TOWN OF WILTON
ADDENDUM NO. 2

RFP #2022-09

**Request for Proposal to Replace Lovers
Lane Bridge - Bridge #04975**

ADDENDUM NO. 2

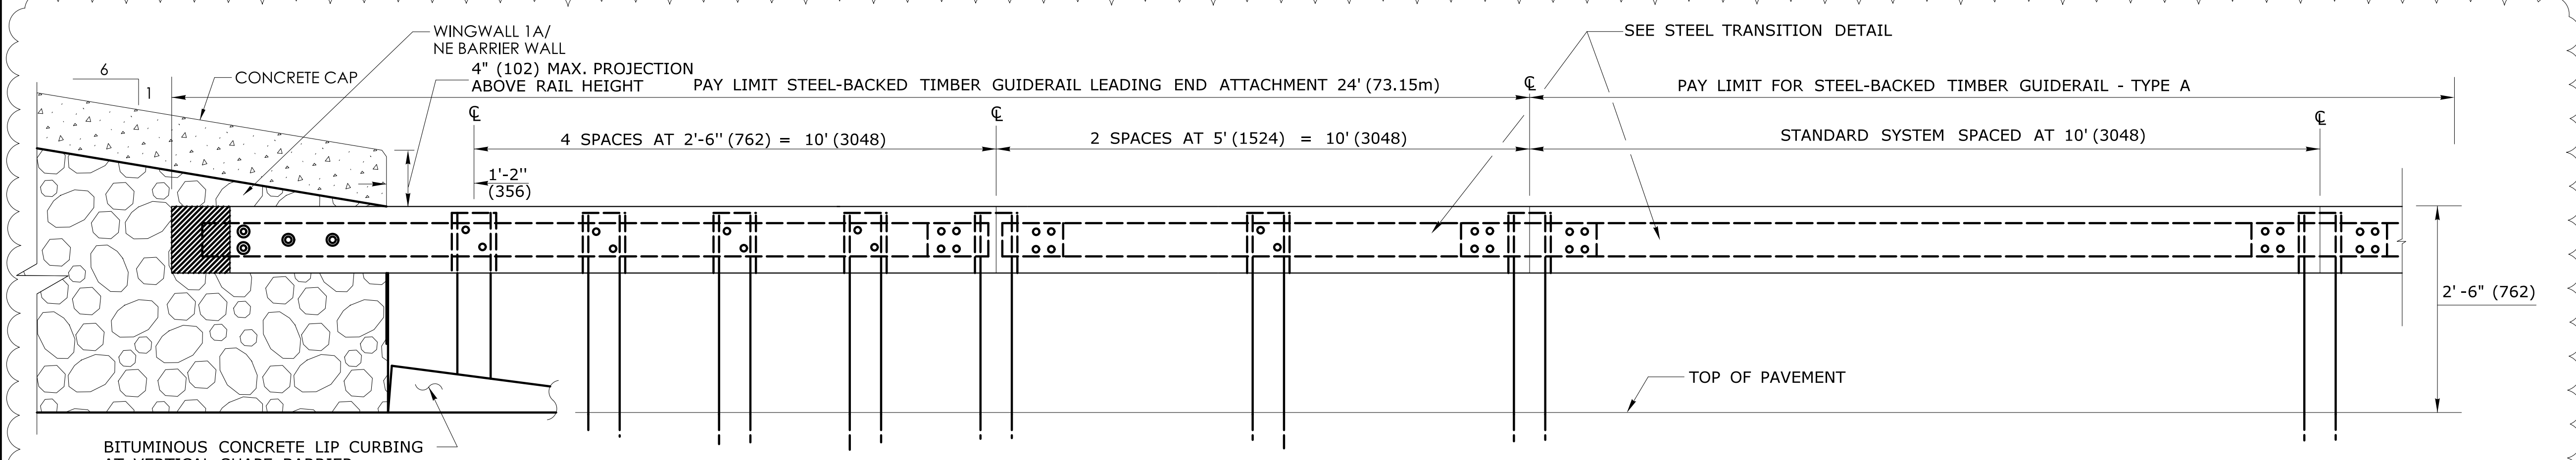
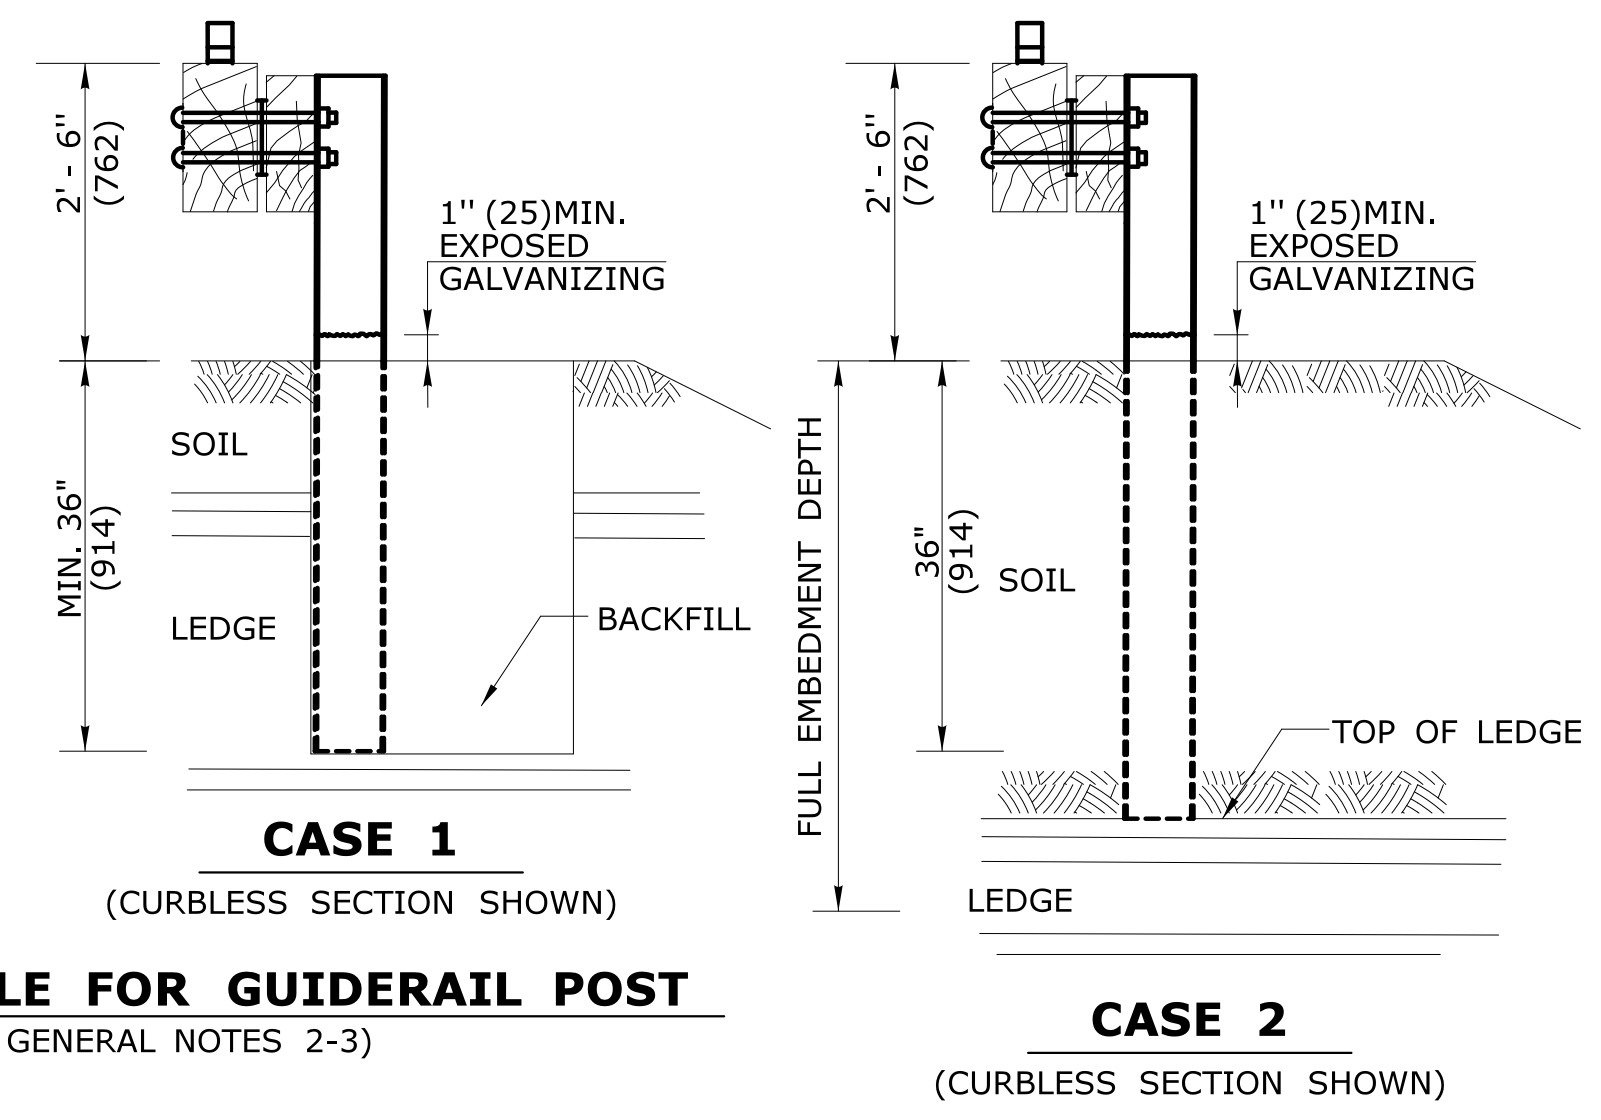
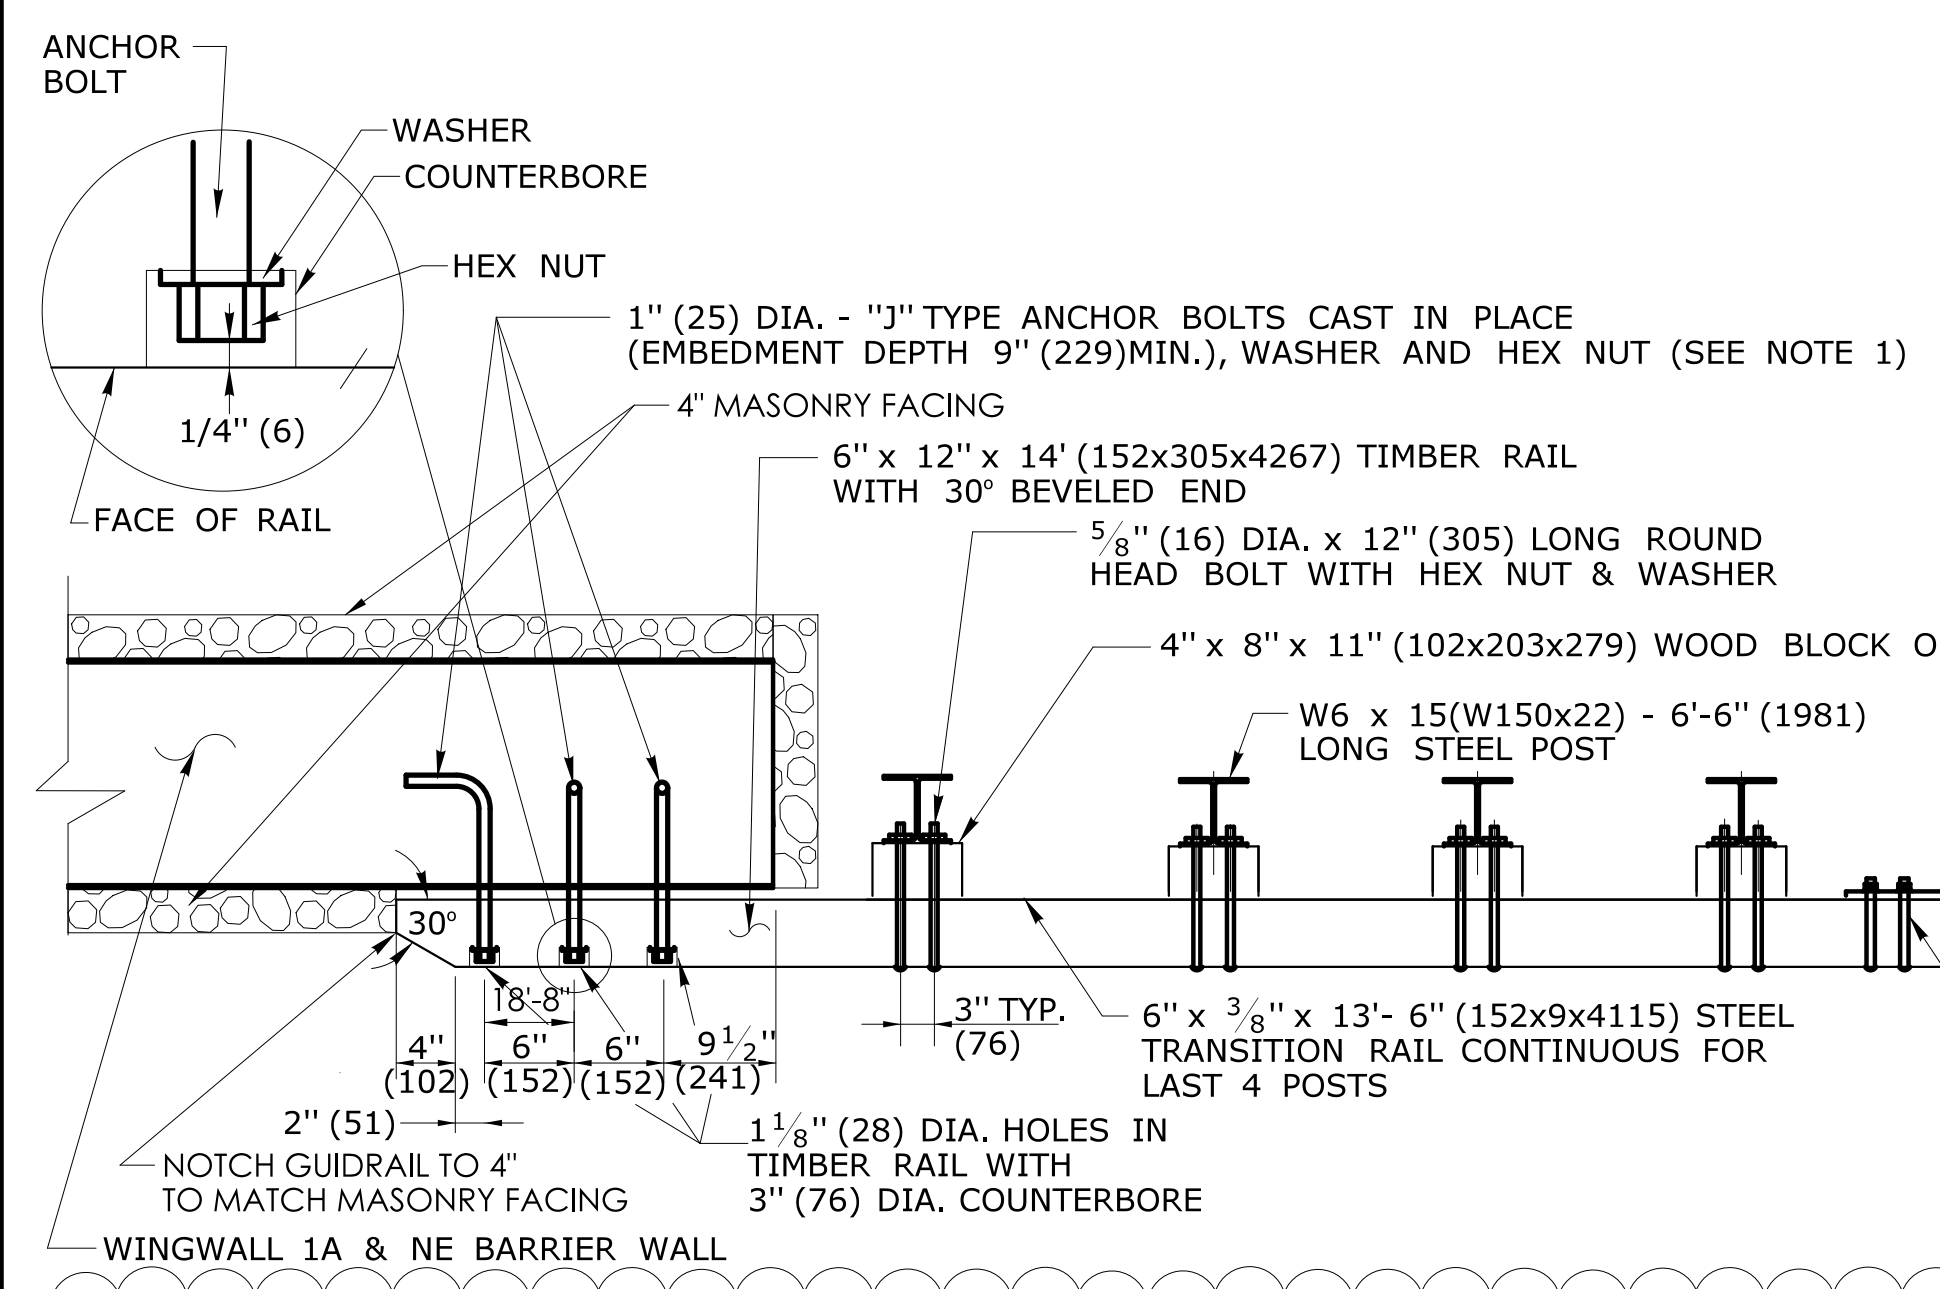
REV.	DATE	CONCRETE CAP MODIFICATION	REVISION DESCRIPTION
1	12/15/22	CONCRETE CAP MODIFICATION	REVISION DESCRIPTION
